POWER AUTHORITY OF THE STATE OF NEW YORK

JAMES A. FITZPATRICK NUCLEAR POWER PLANT

Revised "Application for Amendment to Operating License"
regarding Reload 4/Cycle 5.

FIGURE 3.1-2a
 Operating Limit MCPR Versus τ (Section 4.1.E)
 For 8x8 Fuel Types

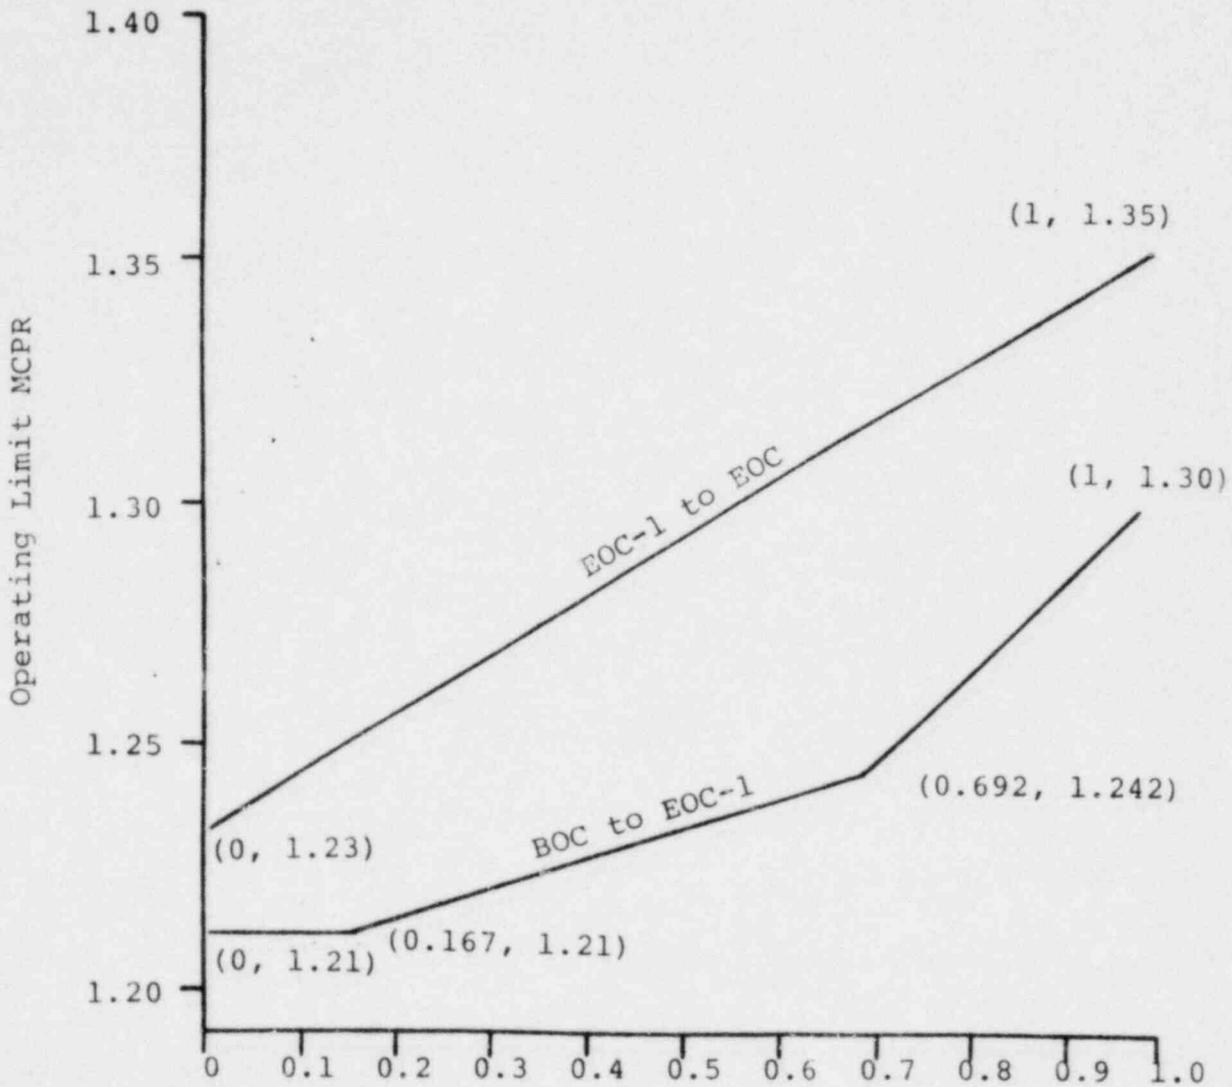
47b - (Figure 3.1-2)

47b - (Figure 3.1-2a),

FIGURE 3.1-2b
 Operating Limit MCPR Versus τ (Section 4.1.E)
 For 8X8R Fuel Types

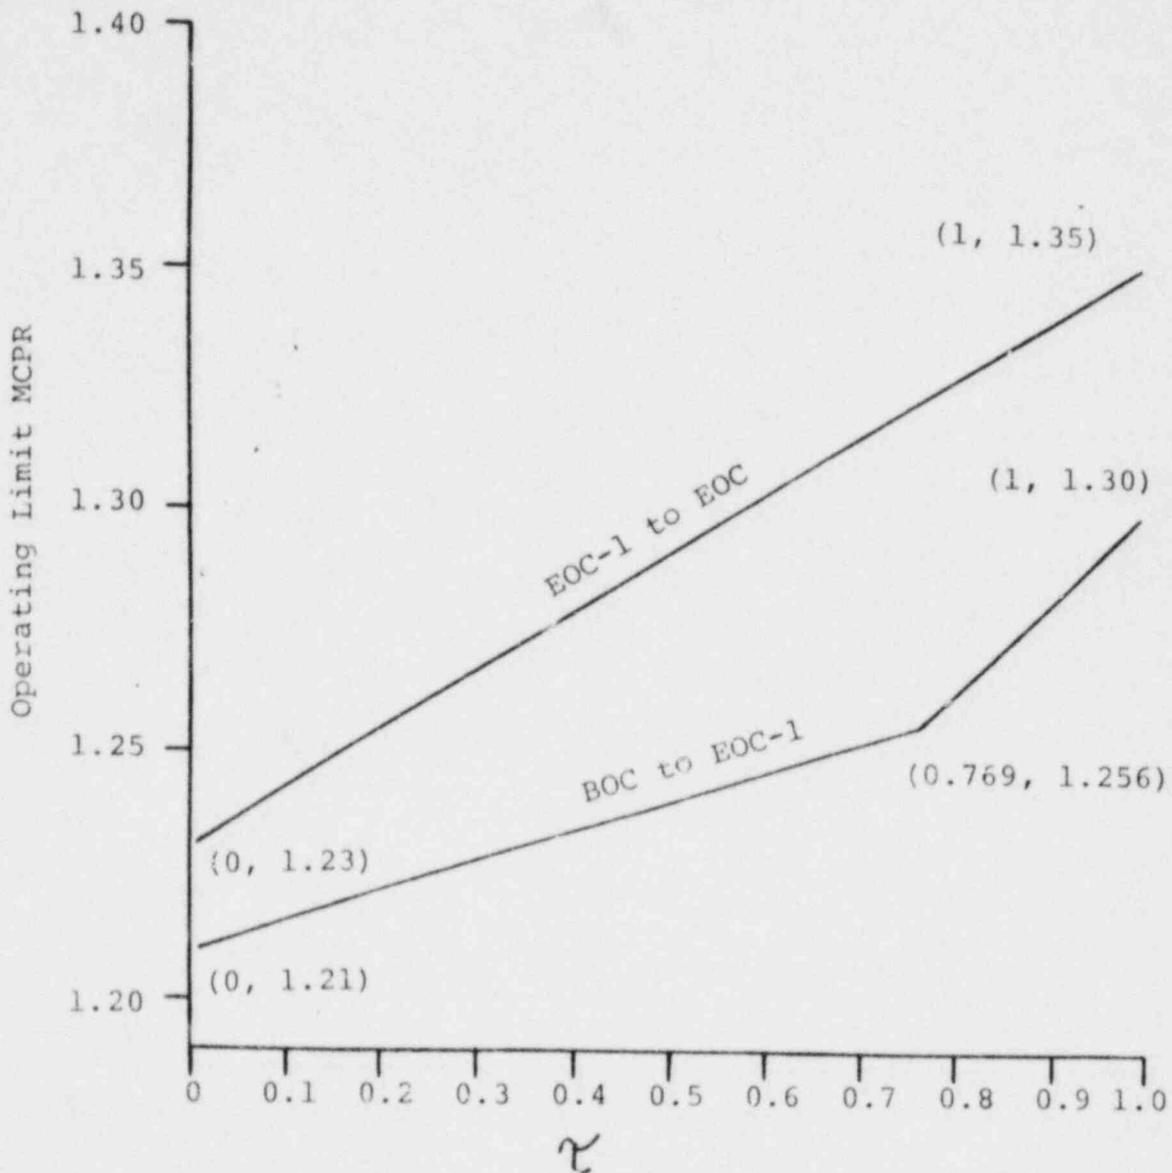
47c - (Figure 3.1-2b),
